CERN MIT L3 A&C/AMS

AMS02-PDS

Request for [X] waiver [ ] deviation

TITLE OF WAIVER / DEVIATION:
PDS radiated E-field emissions out of specified limits

SIDE A

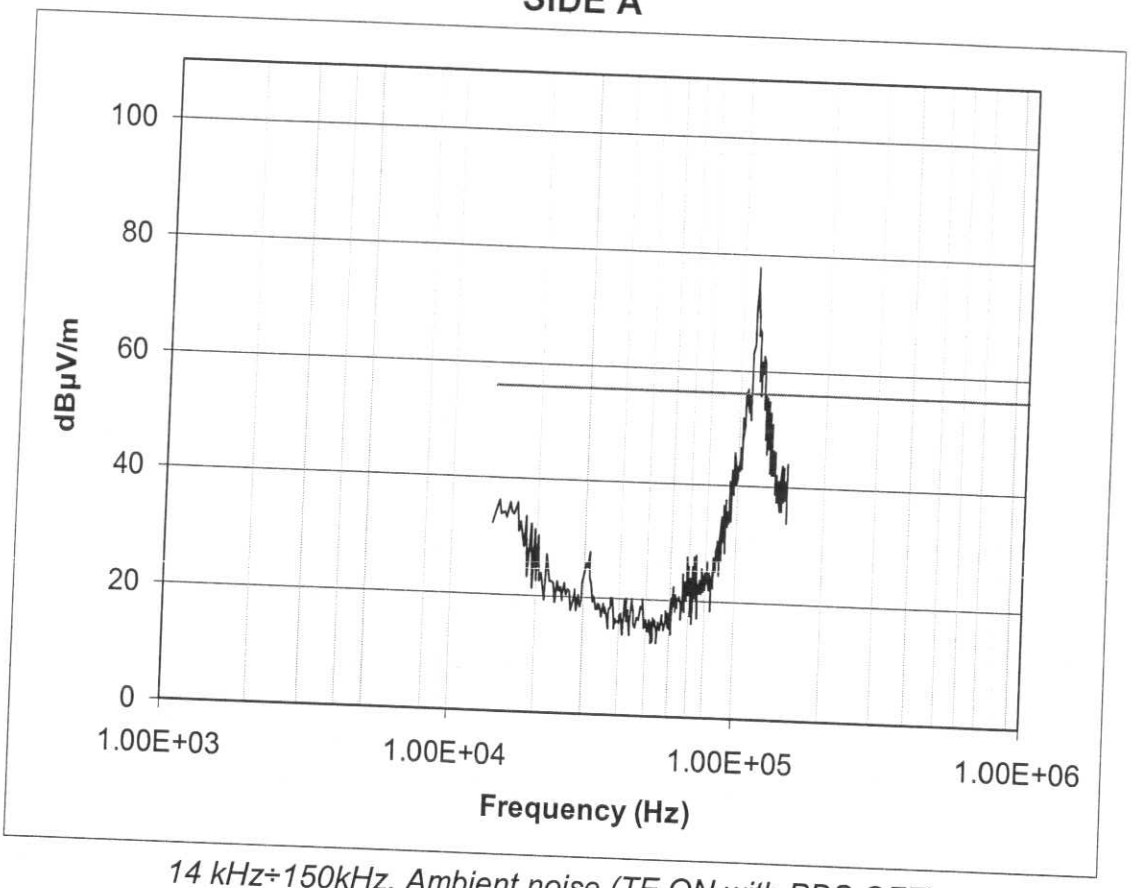
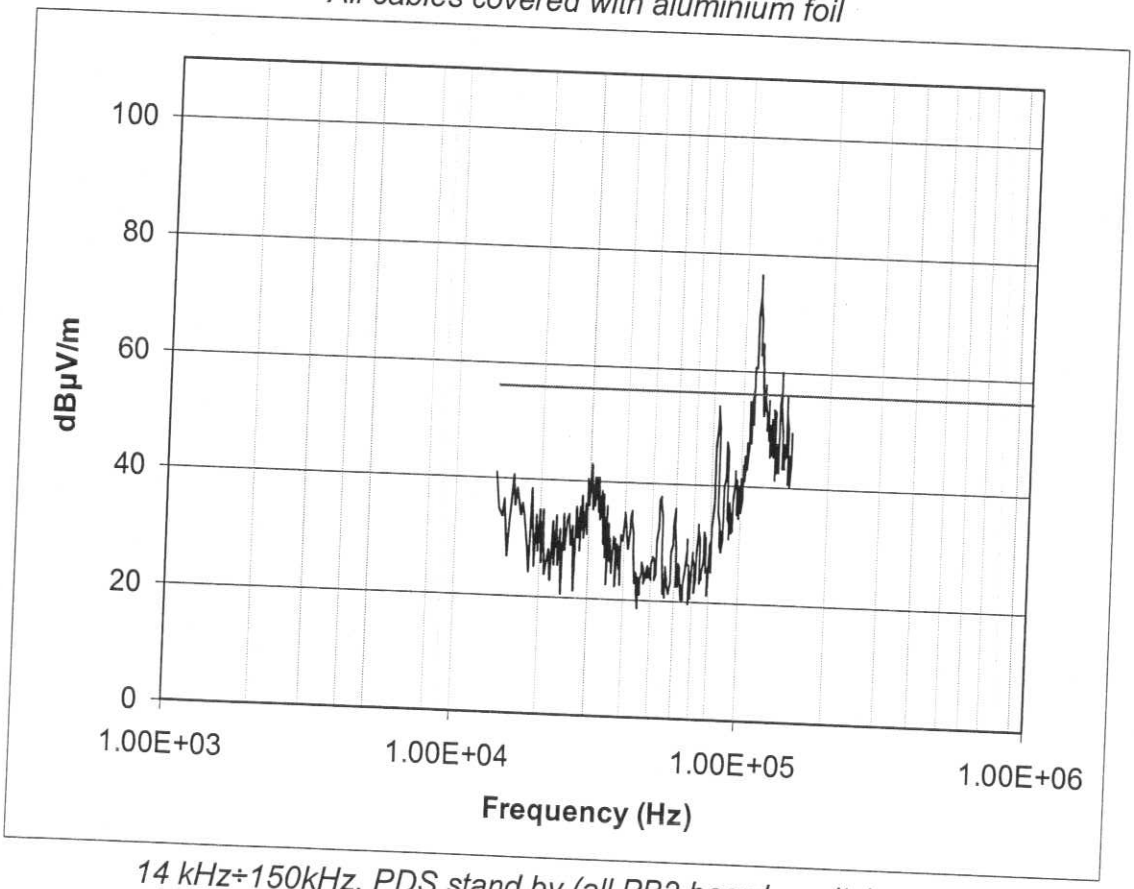
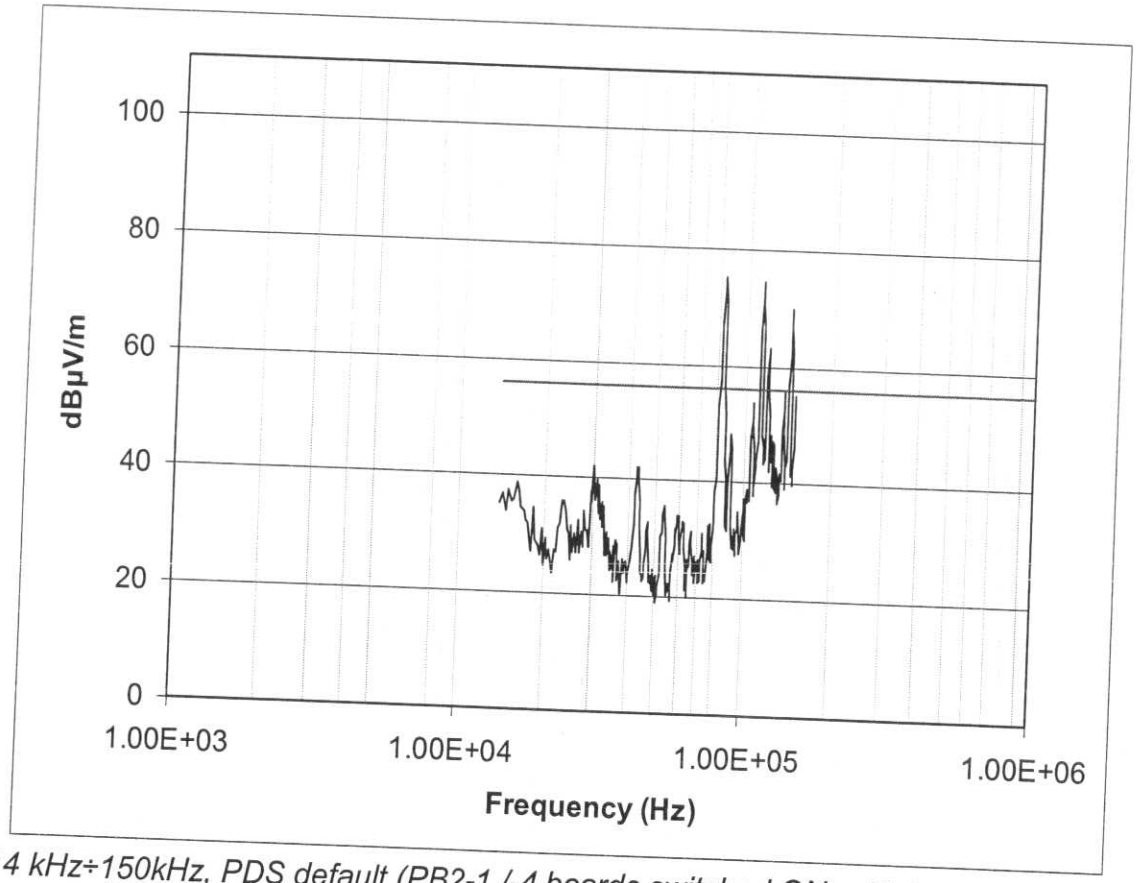
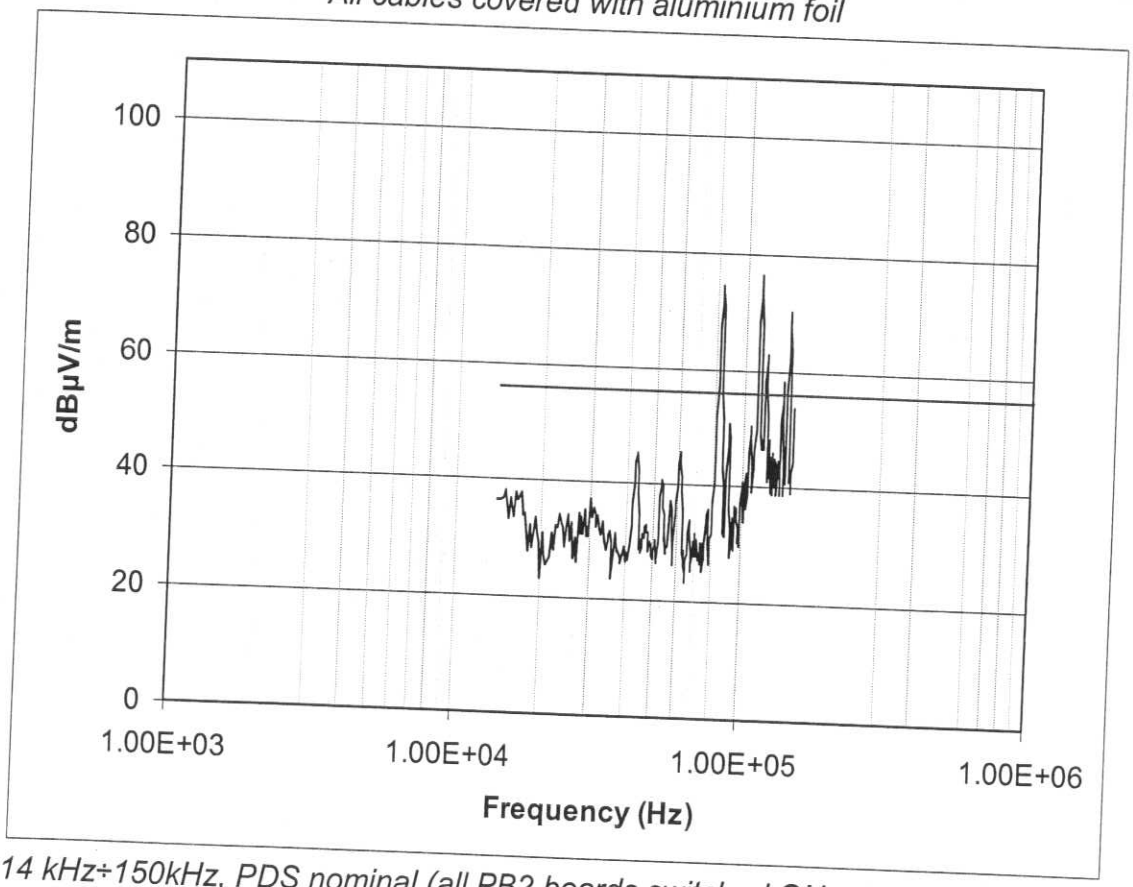
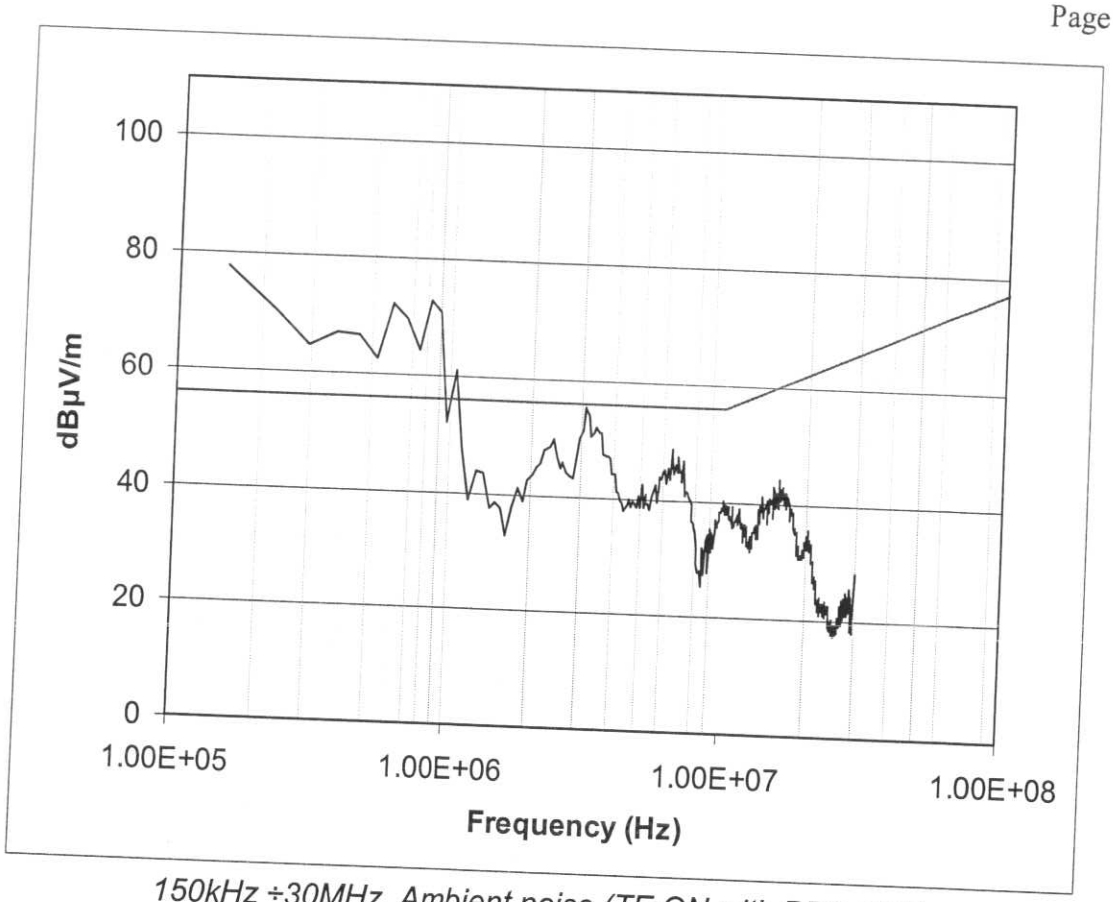
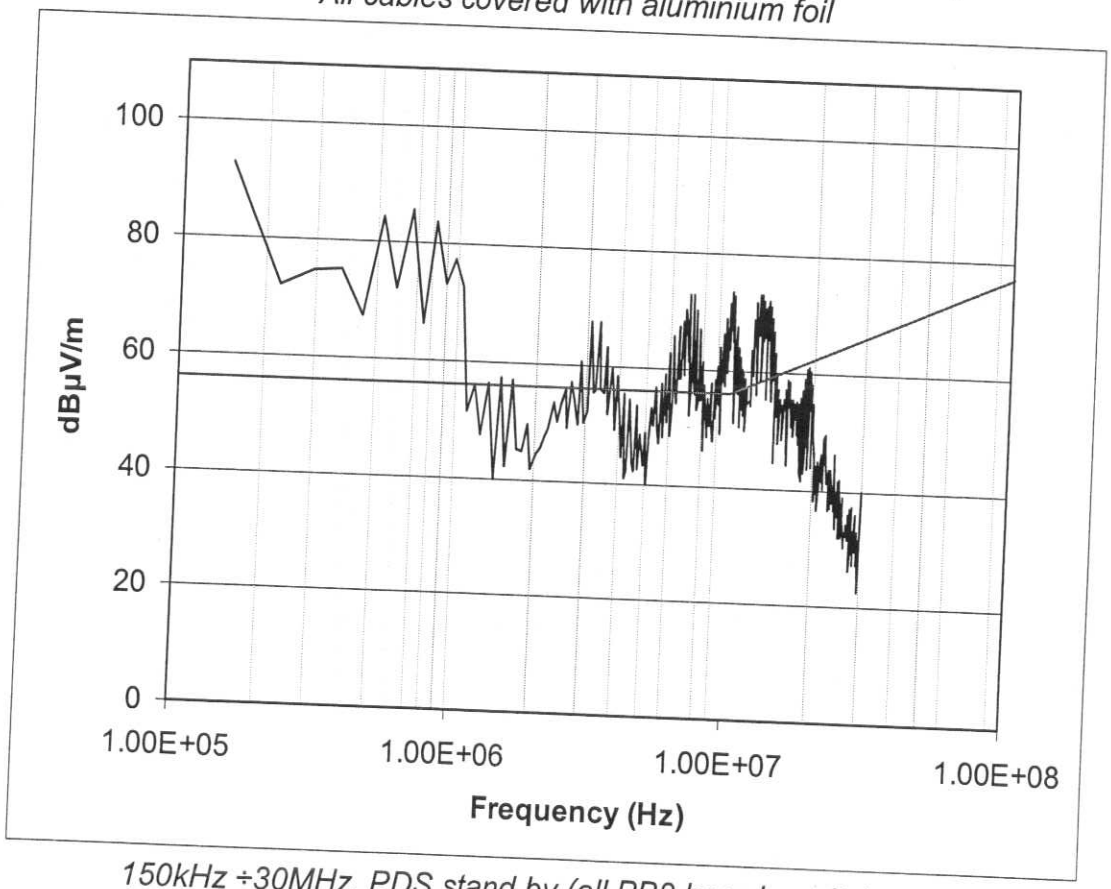
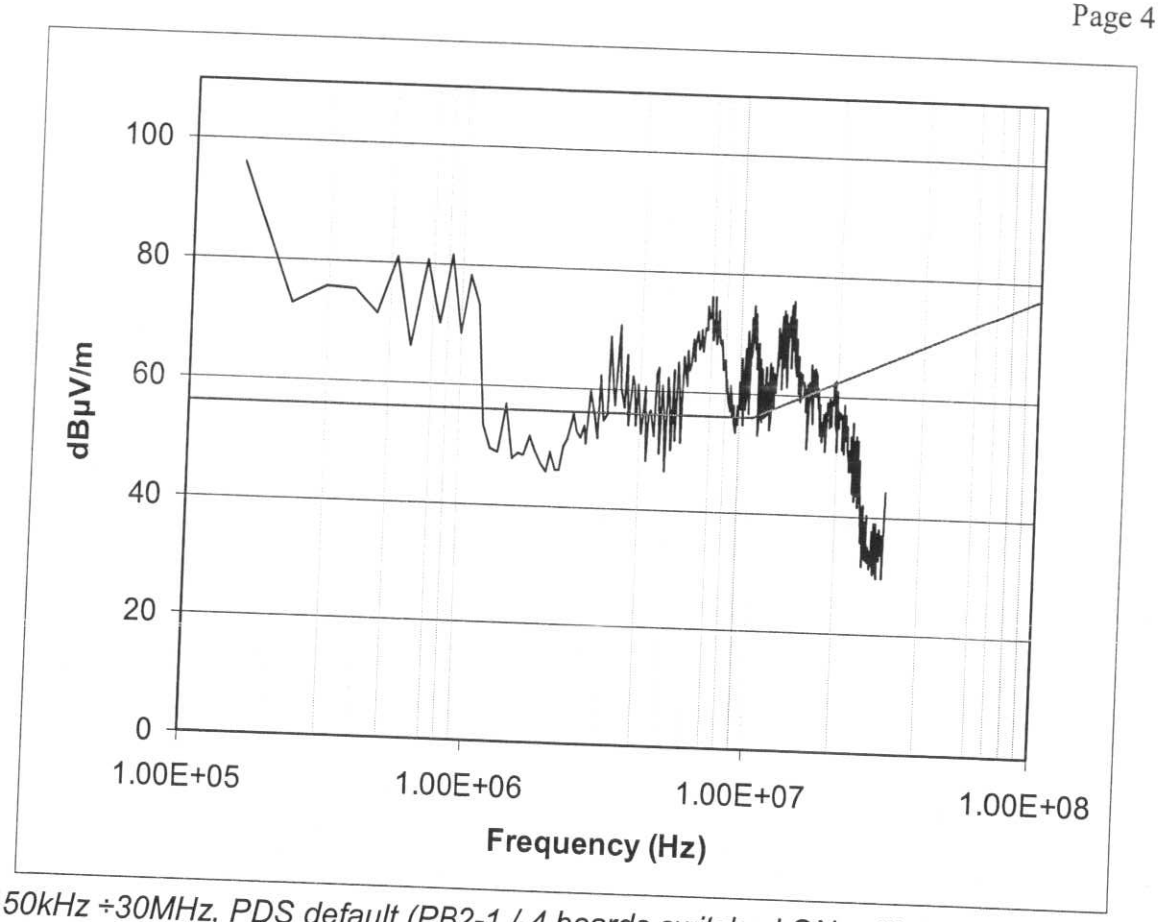
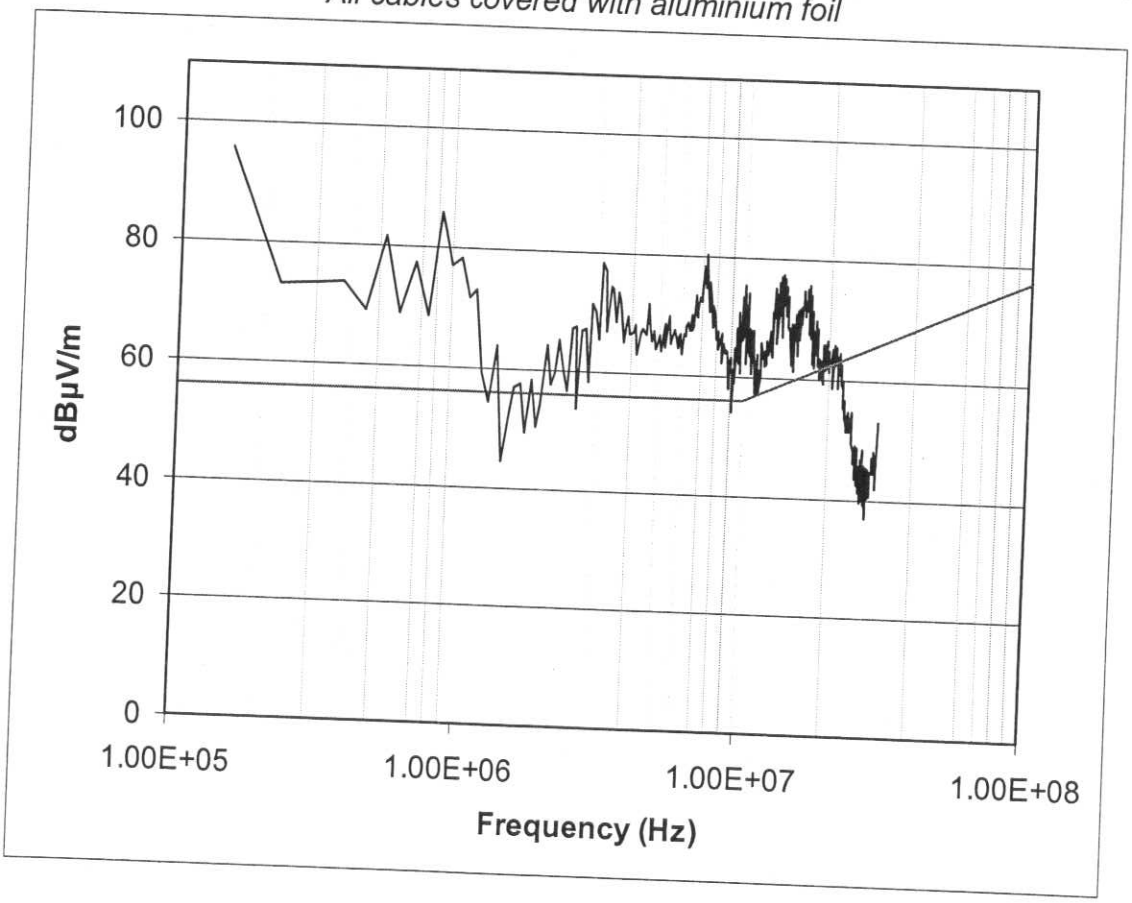
DESCRIPTION OF REQUEST:
To accept that the PDS radiated emissions have been found out of specified limits in the low range of frequency spectrum (from about 70kHz up to about 25MHz) for both side A and side B of unit, see Annex 1.

NEED / REASON FOR REQUEST:
The out-of-spec. value is most probably originated by the use of not shielded cables; shielding performed by wrapping cable bundles with aluminium foil can not be considered as an equivalent solution. Additionally, it is underlined that overall test representativeness is jeopardised by unavailability of flight harness.

PROPOSAL / RECOVERY ACTION:
To use the unit as it is.
